**Antarctic Research Vessel Science Advisory Sub-Committee (ARV SASC)
of the Office of Polar Programs (OPP) Advisory Committee**

Report on DR #5, September 15, 2023

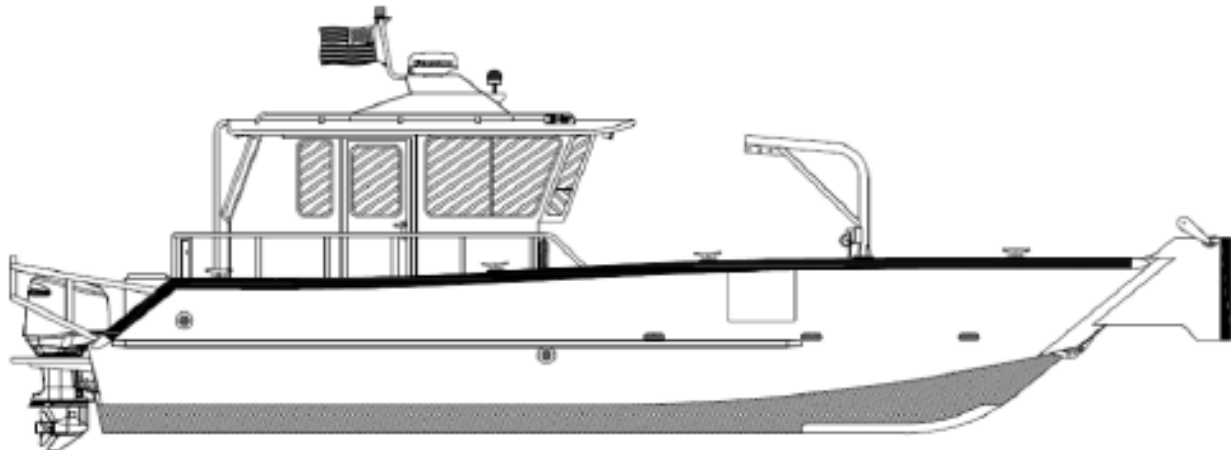
The **Landing Craft** (30-34 ft long and 12 ft max width) is intended to be used to facilitate access to shore-based science, with a capacity for 2 crew and 4 (threshold) - 6 (objective) scientists. As described in DR #5 documents, "The LC will be a platform for science with a mission of transporting crew, scientific equipment, and shelter supplies to and from the beach and/or ice in a safe and cost-effective way with minimal impact to the local environment." This includes the ability to transport vehicles, such as a standard sized 4-wheeled ATV, that can then be used to move people and equipment once ashore. The LC also will be able to deploy, retrieve and tow glider packages. At National Academy meeting, colleagues expressed interest in the speed/range of landing craft:

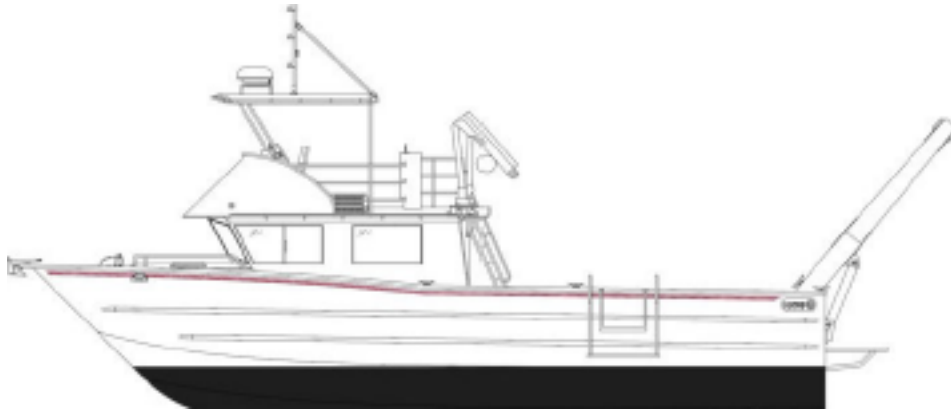
The **Scientific Survey Workboat** (~30 ft length, width 12 ft max; capacity for 2 crew and 4 (threshold) - 6 (objective) scientists) "will be a platform for science with a mission of conducting scientific experiments and collecting high quality data in a safe and cost-effective way with minimal impact to the local environment." This includes the ability to support scientific diving. Like the LC, this boat will be able to deploy, retrieve and tow glider packages. It will have an ice window for sonar (Shallow Water Multibeam equivalent to EM 712), a research winch and an A-frame. Examples of the kinds of science that could be conducted from the Science Survey Boast include acoustic surveys, net tows, CTD casts, light geophysics (CHIRP, sparker and towed profilers), surface water sampling and mooring / instrument recoveries.

Details regarding speed/range:
